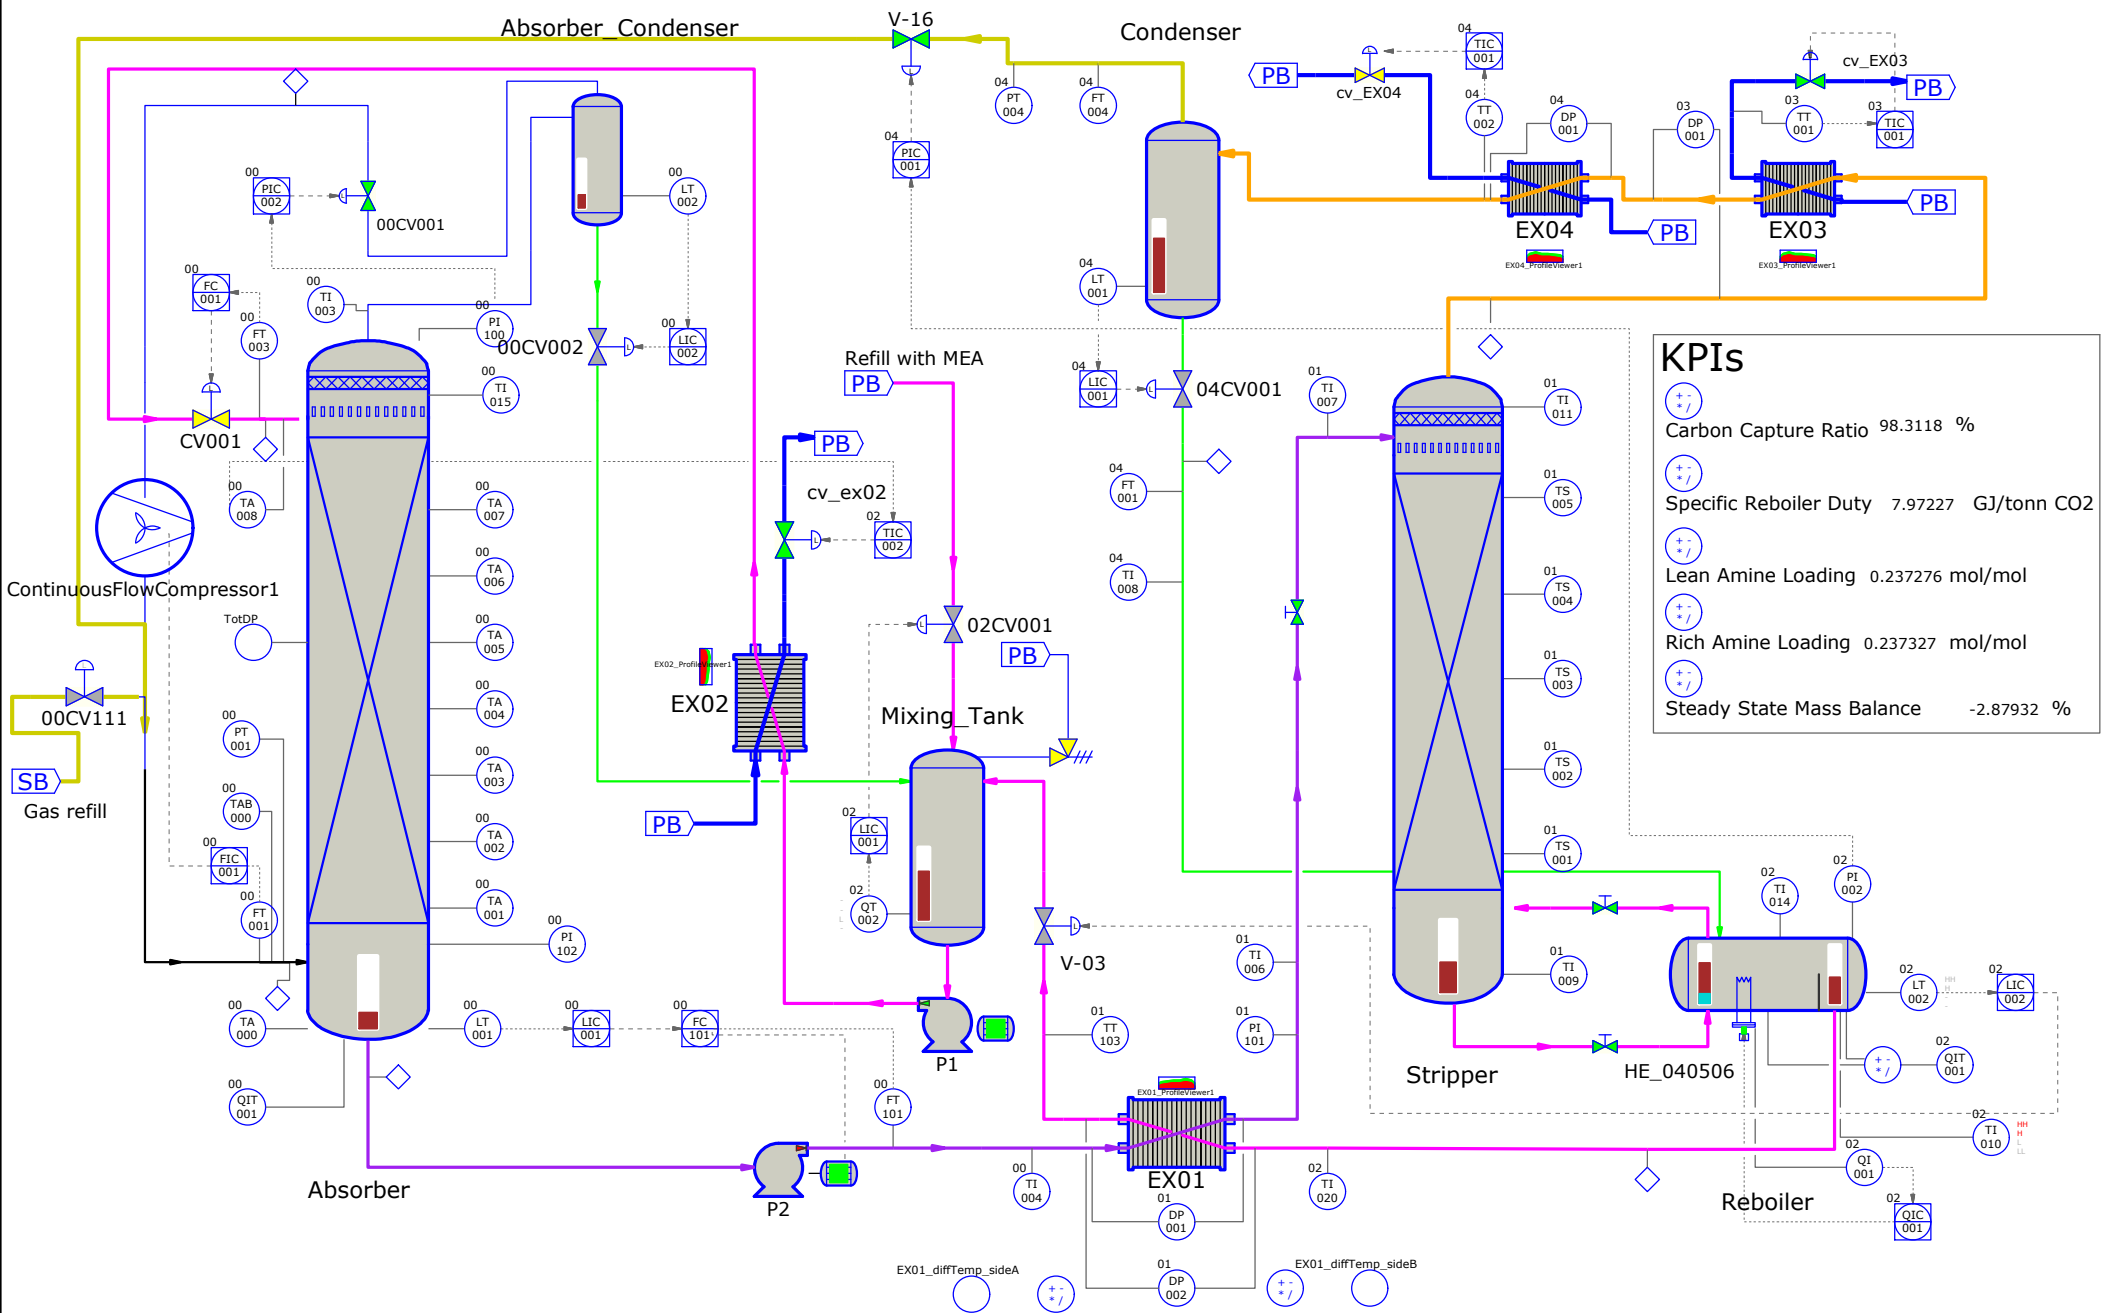
Rich side DP 1.5 bar. Probably too much
 bar. Use reference flow for pressure drop
